# GROUNDWATER TECHNOLOGY, INC.

June 25, 1991

Job No. 020301074

Subject: Proposed Monitoring Well Installation Addendum  
Chevron Service Station #9-0121  
3026 Lakeshore Avenue, Oakland, California.

Figure 1. Proposed Well Locations

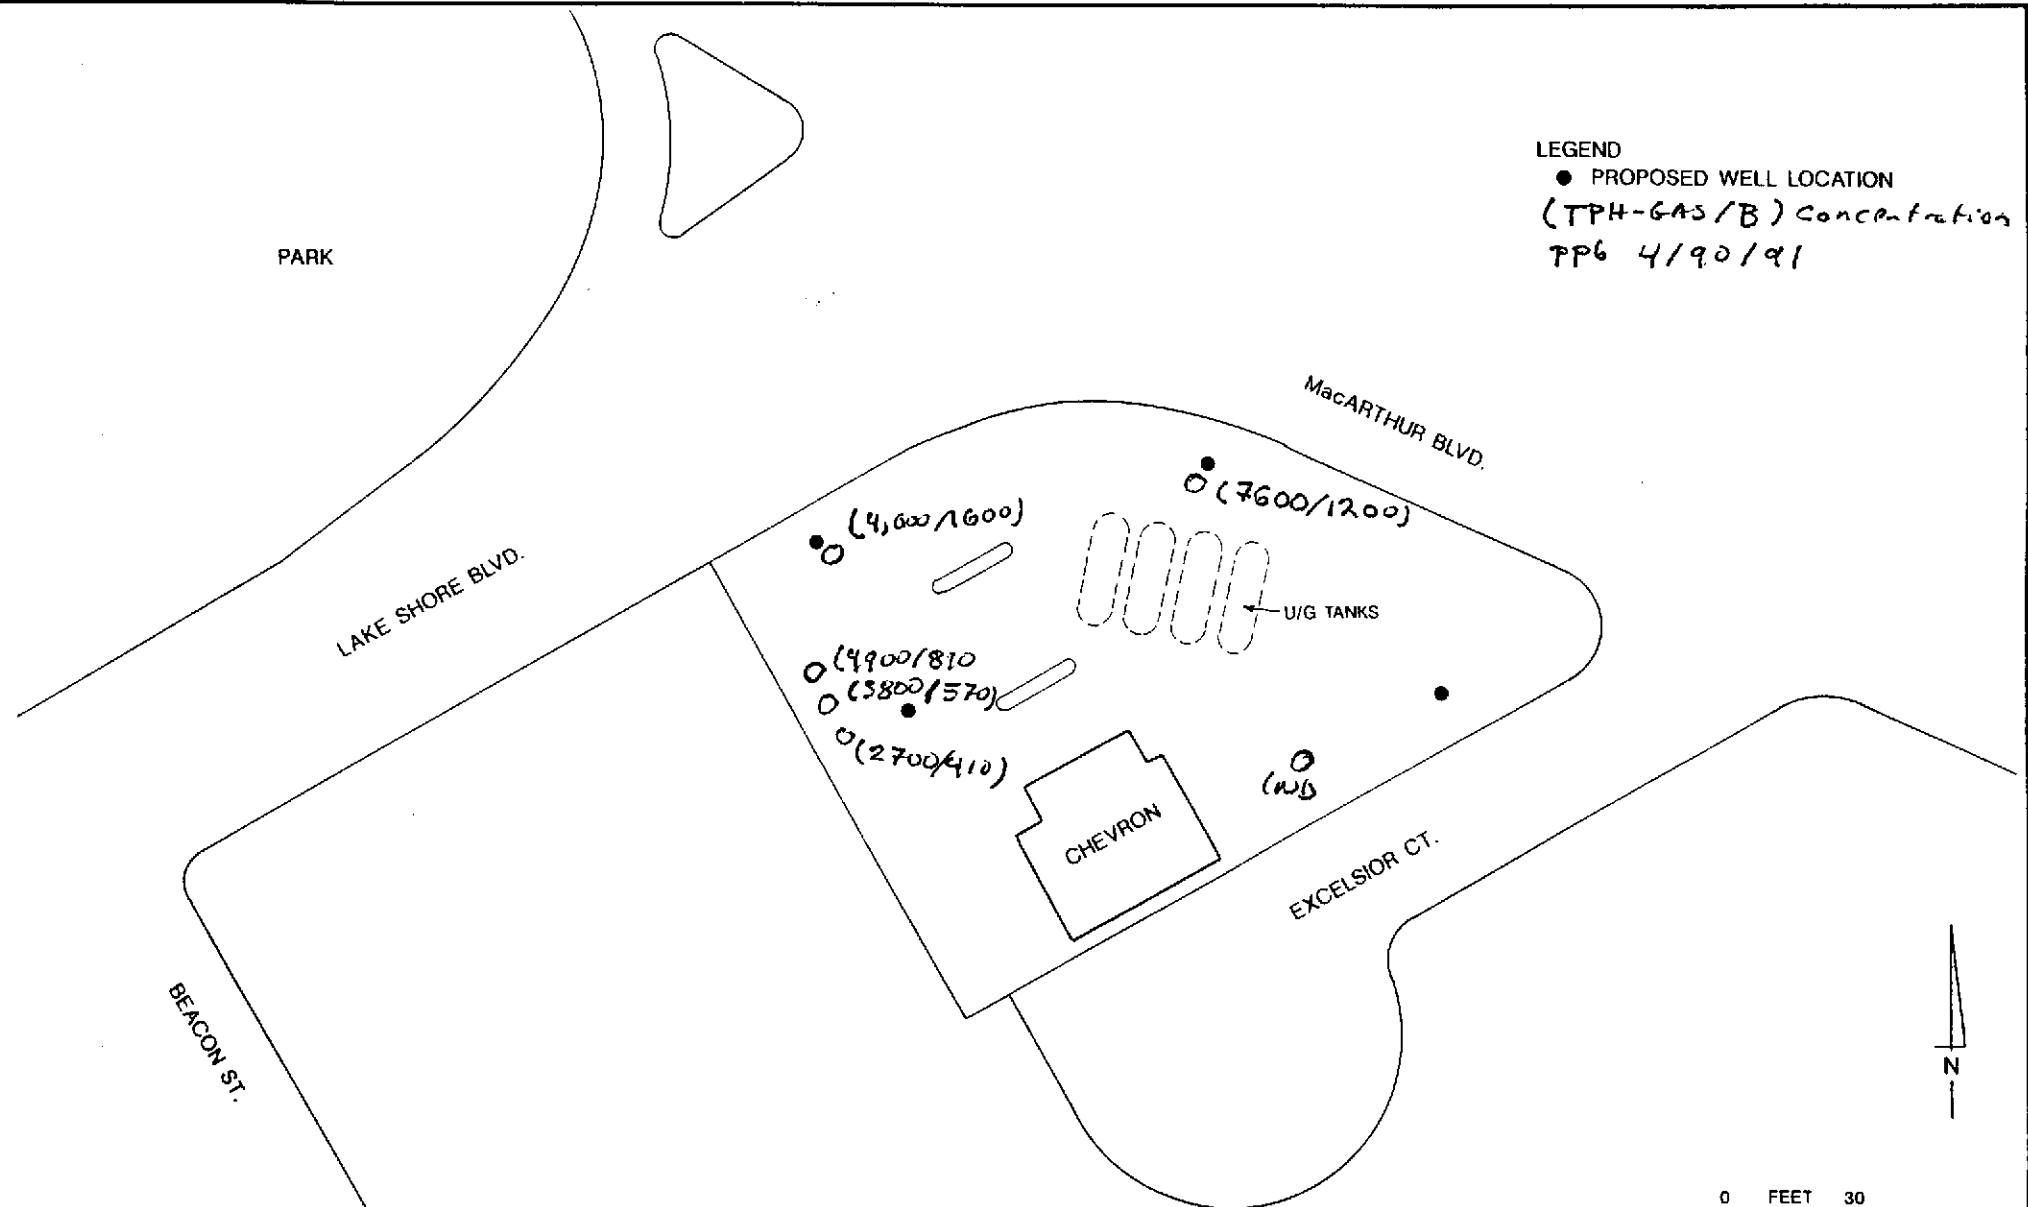
1. As the map which was faxed to your attention on June 14, shows (a copy of which is attached to this letter) two of the proposed well locations are directly adjacent to former well locations. When last sampled, the former wells showed that levels of dissolved petroleum hydrocarbons ranged from non detectable to 7,600 parts per billion (ppb). The other two wells proposed to be installed for this site are intended to provide a general picture of the distribution of dissolved hydrocarbons beneath this site. It is expected that well installations, in addition to the four currently proposed, may be required to fully define the extent of the dissolved hydrocarbons.
